No. 231

April 19, 1961.

DISC BRAKES

SUNBEAM ALPINE SERIES I & II

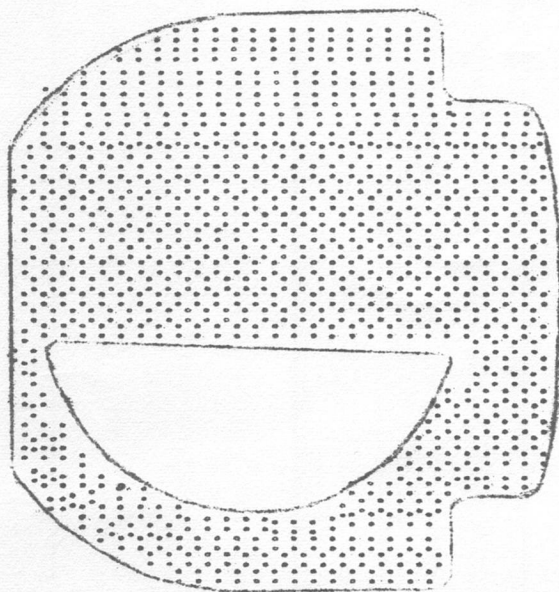
Where complaints are received in respect of "squeal" on the disc brakes fitted to the front wheels of the above model, this can be overcome by fitting special anti-squeal shims.

- (1) Jack up the front of the car and remove the road wheels.
- (2) Remove the retaining pins and clips used to secure the brake pads in the calipers.
- (3) Clean off any road dirt or grit found on the pad backing plate. Insert the shims supplied between the front of each piston and the rear of each brake pad. When fitted, the semi-circular cut-out on the shim should be facing downwards, away from the bleed screw, and the tongues should be facing outwards. (See illustration).
- (4) Refit the retaining pins and clips. Refit the road wheels and lower the jack.

The shims, of which four per car are required, can be obtained through the normal Parts channels against Part Number 1206222.

These shims have been fitted in Production from Chassis Number B.9103936.
